Report on Consultation – Alignment  
Dunoon to Loch Long 132 kV OHL Rebuild

November 2022

REF: LT000193-WSP-ENV-RPT-008

Scottish & Southern  
Electricity Networks

Title: **Figure 7.1  
Proposed Alignment  
Sheet 1 of 4**

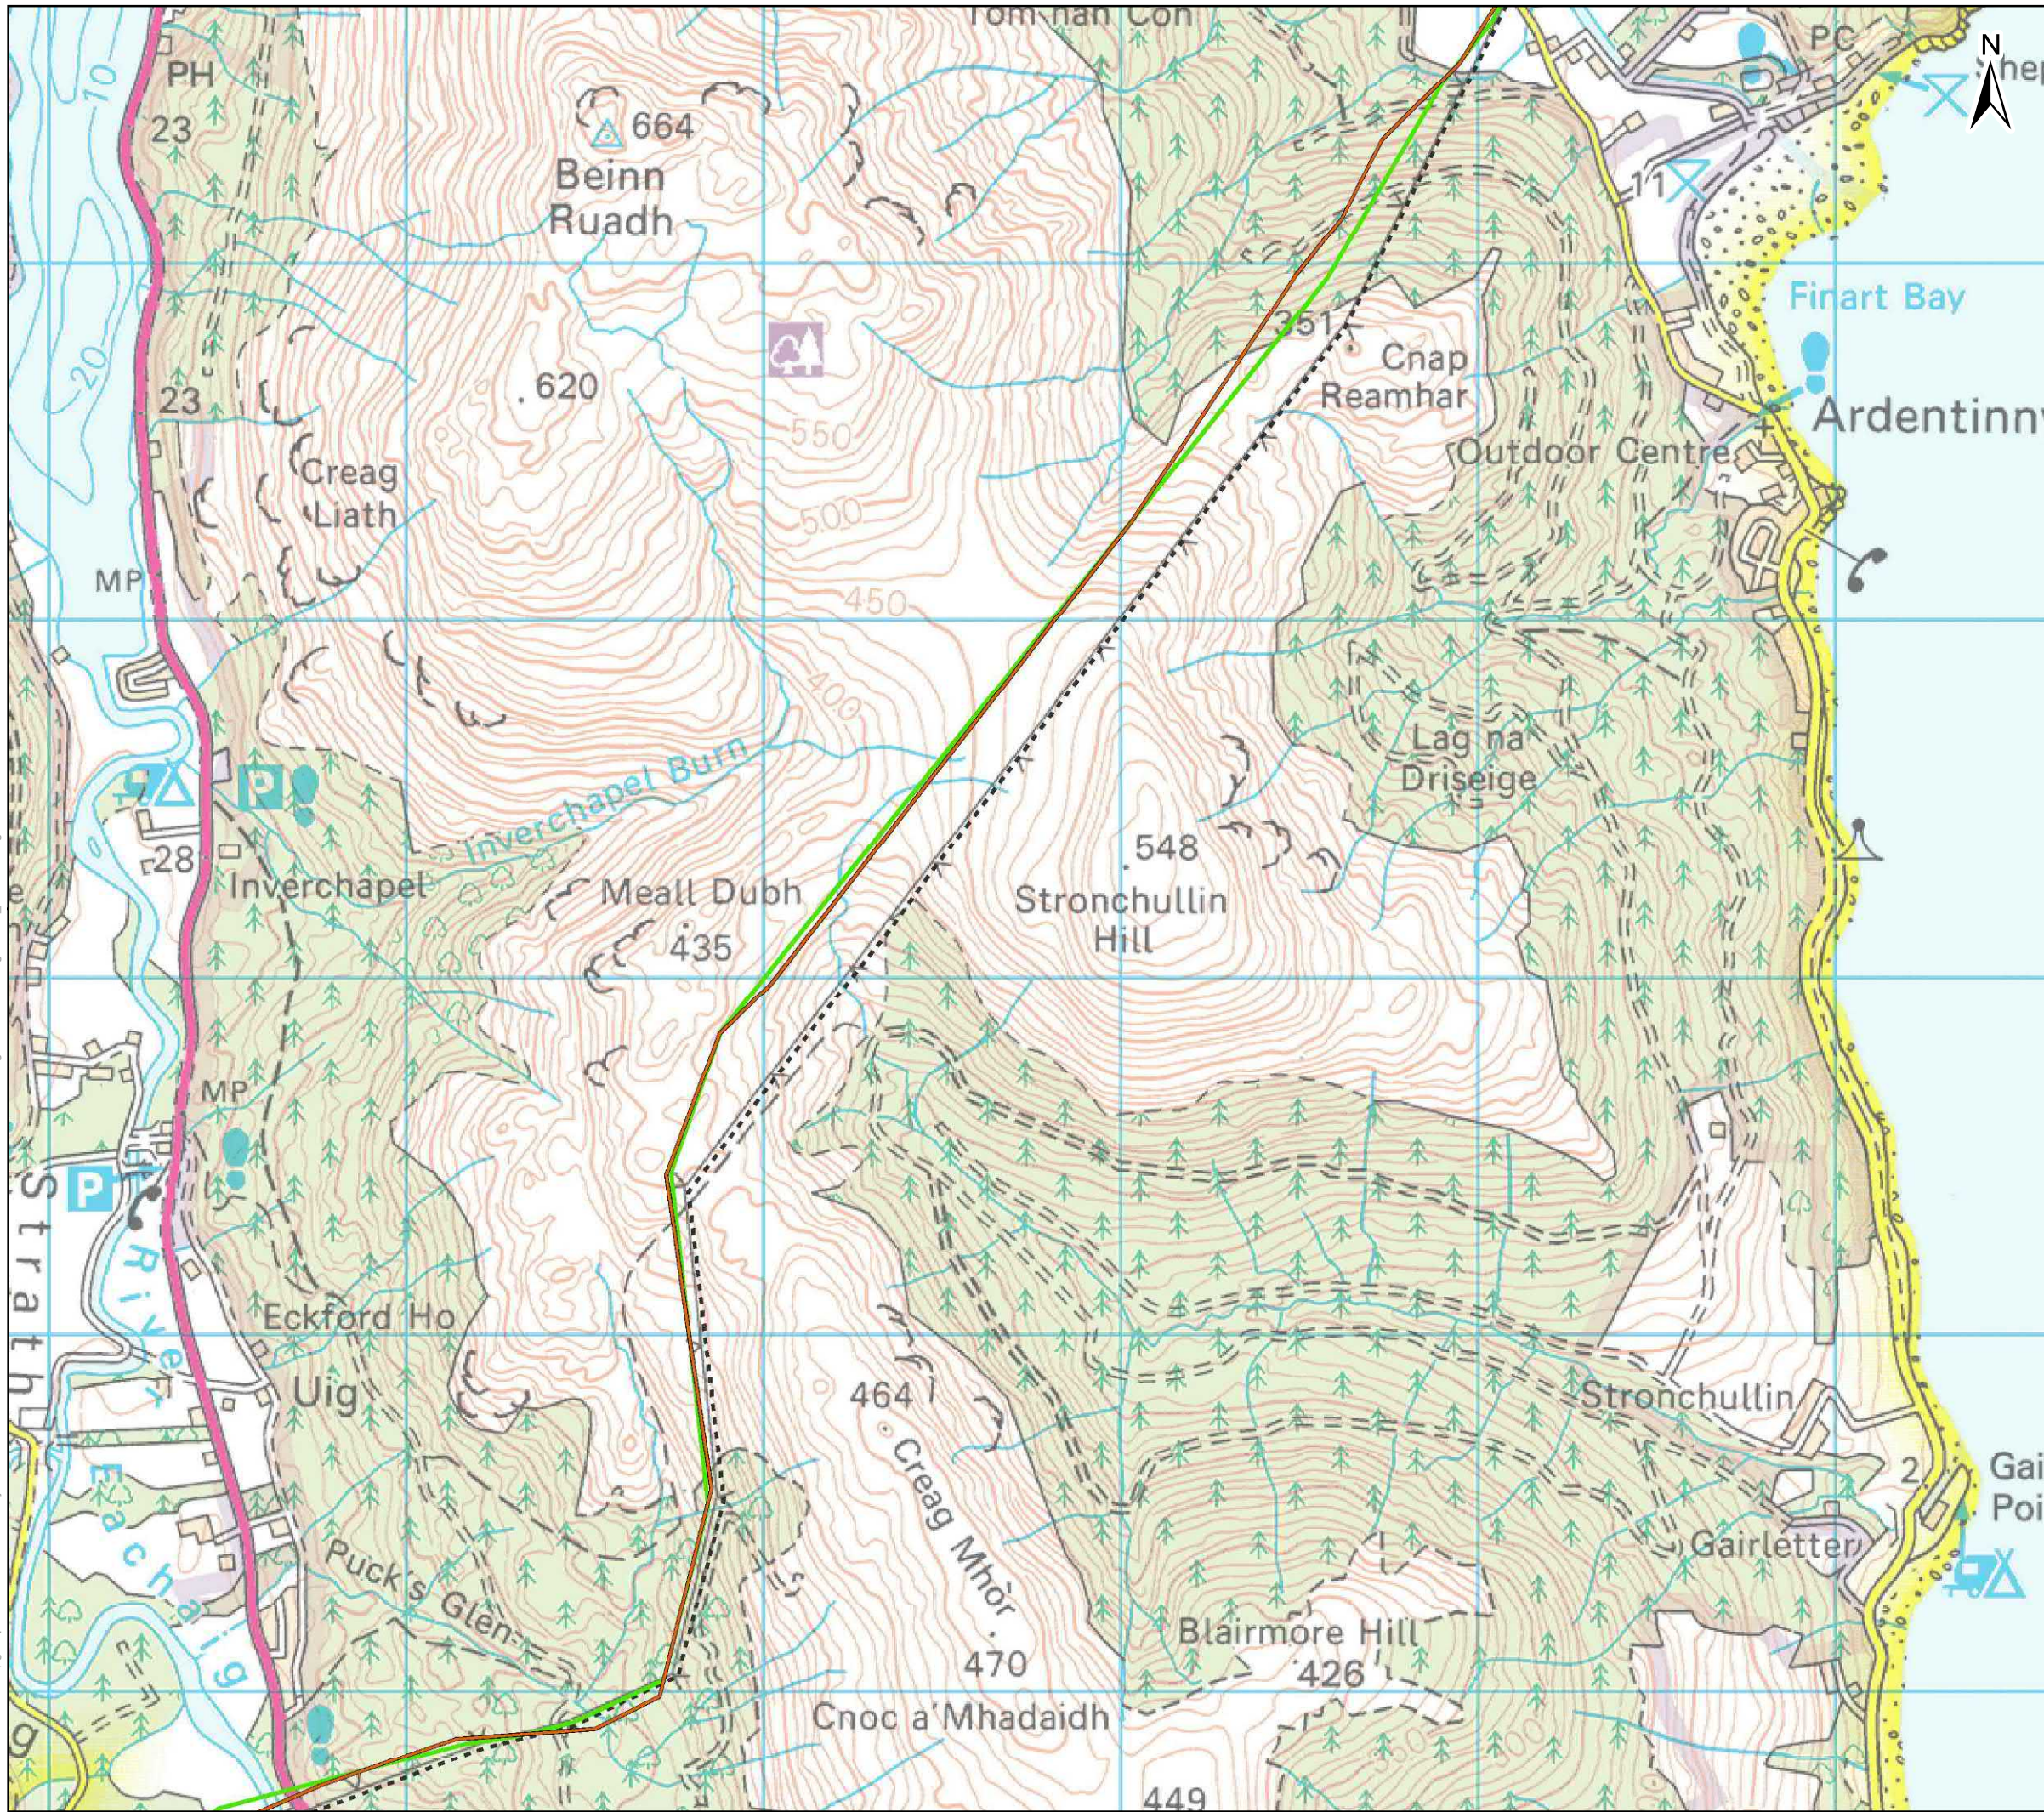
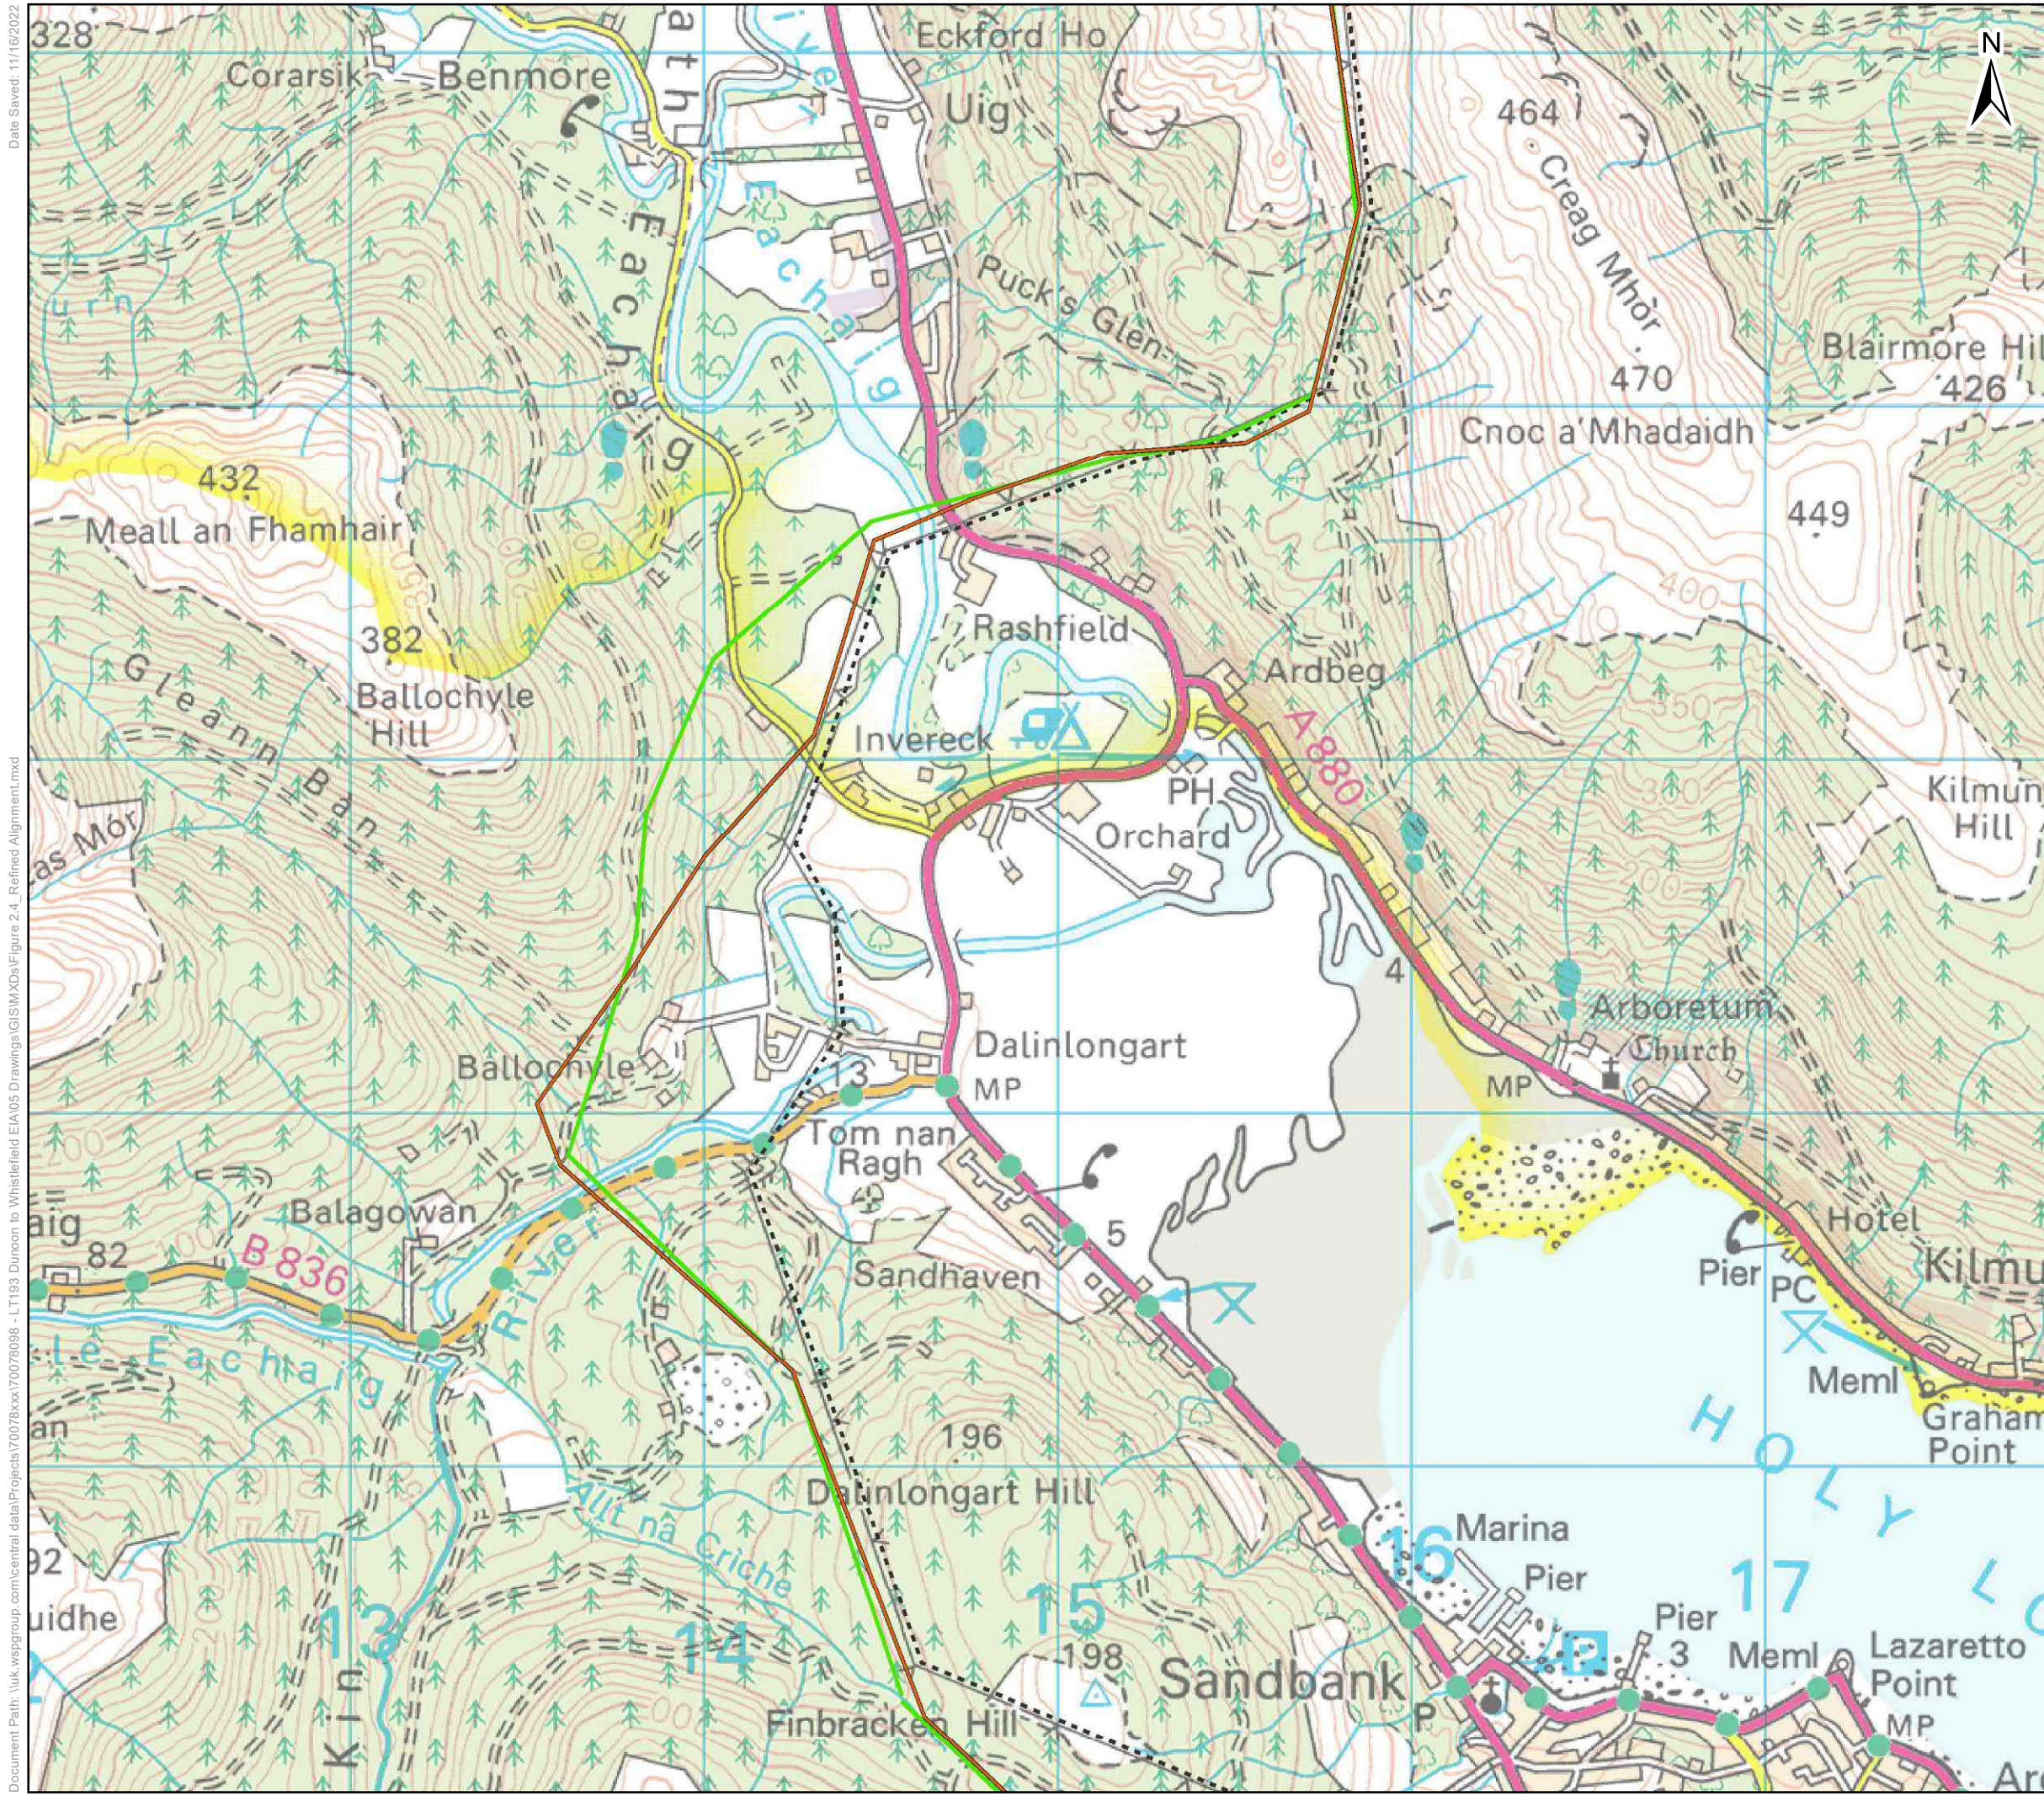
In response to public consultation feedback regarding visual effects within Section 5, during refinement the alignment was moved further away from residences and further up the hill to increase distance from residential receptors.

In response to public consultation feedback regarding visual effects, potential effects on private water supplies and forestry management a deviation to the consulted alignment was proposed within Sections 1, 4 and 5 of the Proposed OHL Route to reduce potential effects.

This revised alignment keeps the OHL down-slope of the PWS sources, thus significantly reducing the risk to these during construction. The revised alignment also significantly reduces the height of the replacement OHL on the landscape, reducing potential landscape and visual impacts to receptors looking across to the hill. By limiting the height of the alignment on the Ballochyle hill, the visual impact on receptors leaving Sandbank/ Dunoon on the main road (A815) will be reduced. During consultation with the Ballochyle community this landscape impact was highlighted as being increased due to the necessary tree felling required to form a cleared corridor associated with the replacement OHL. It is noted that bringing the alignment off the hill sooner, tying into an alignment along 5C would reduce this effect, as well as reducing the length of the replacement line transecting forestry areas, subsequently reducing associated forestry impacts.

The revised alignment also removes partially skylined towers being visible from residential dwellings and moves the alignment of the replacement OHL closer to the existing OHL alignment which was an approach generally supported throughout consultation exercises.
